**Laurel Ridge  
Senior Housing  
Development**

**East Hampton  
Connecticut**

**Eastern Connecticut  
Environmental Review  
Team Report**

**January 2002**

Figure 3.

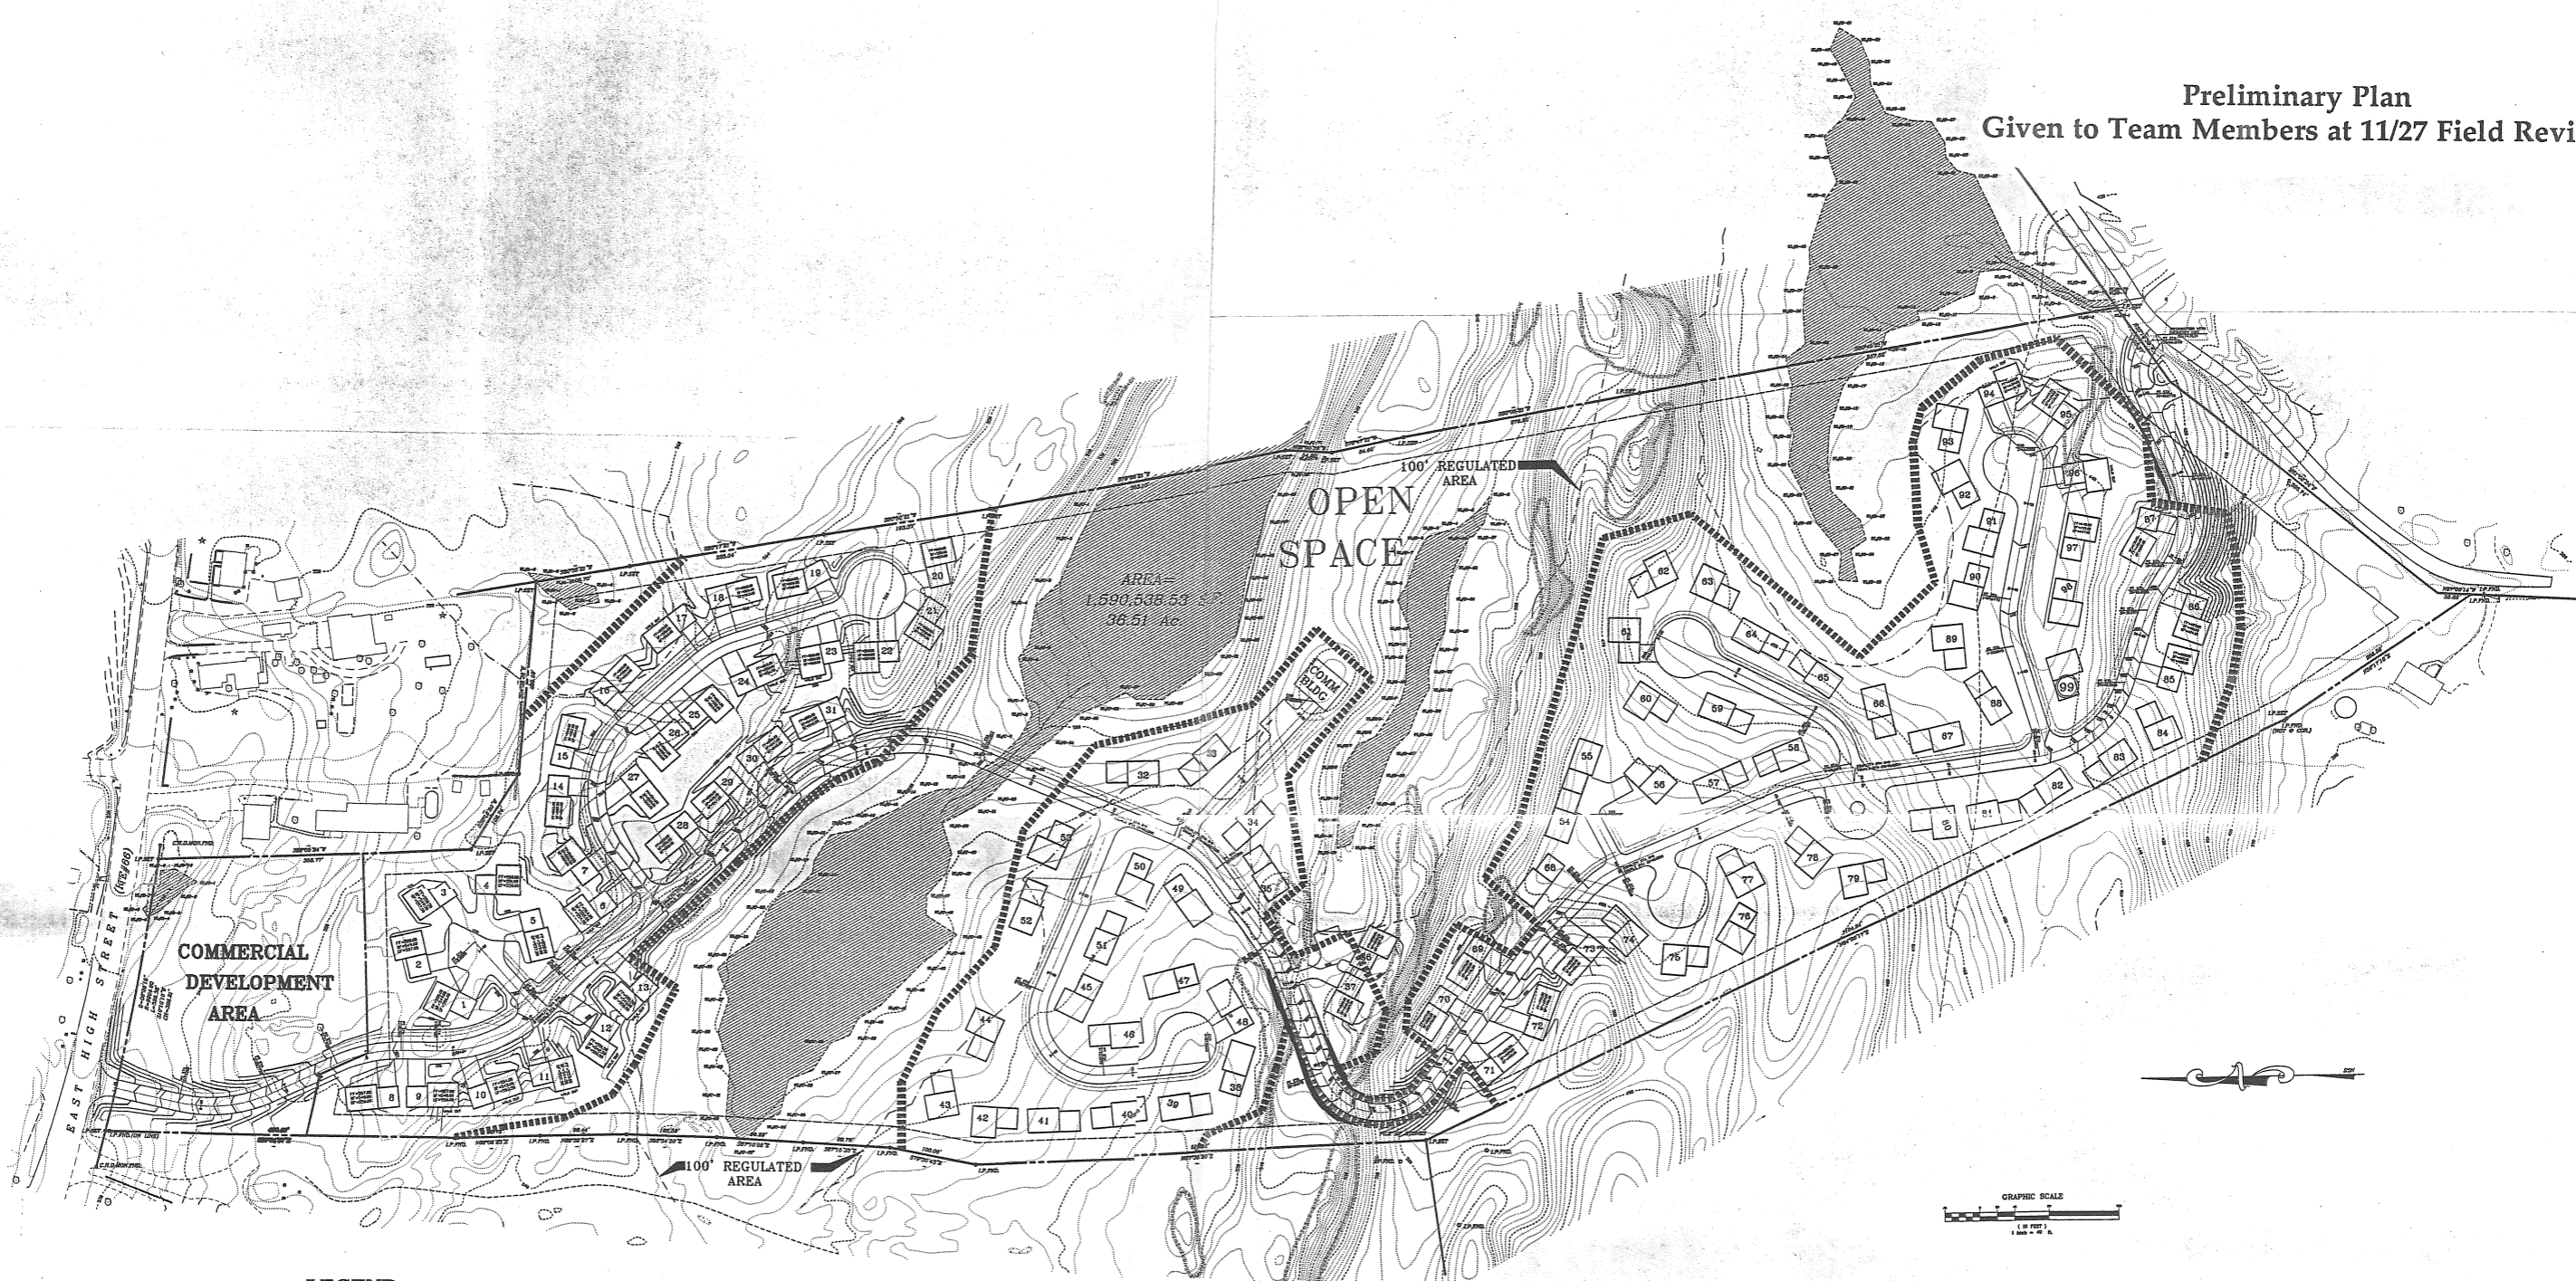
for units immediately adjacent to wetlands (units 13, 16-17, 20-21, 27-35, 42-44, 52, 62-64, 88-93). Overall, many of the units are located on steeply sloped areas.

- 2. Request that the existing vegetation surrounding the wetlands be protected to the maximum extent possible in order to protect plant and wildlife habitat within the wetland corridor.
- 3. Consider the impact of residential housing on the wetlands. Housing units 13, 16-17, 27, 35, 44, 52, 64, 88-93 are located within the 100-foot regulated wetland area.

No provisions to treat stormwater from the roads are indicated on the preliminary plan.

On the small map handed out to the ERT Team and the subsequent larger map dated 12-04-01 sent by Mr. Dimmock there is an error in the orientation of the North arrow which led to some confusion early in the discussions. This should be corrected on the final map for future reviewers to aid in the correct alignment and correlation to the actual landscape and/or other maps. In addition, there is confusion over the scale of the 12-04-01 map. While in print it reads that one inch represents 40 feet, one measured inch on the graphic scale actually more closely represents 50 feet. This also needs to be rectified in the final version.
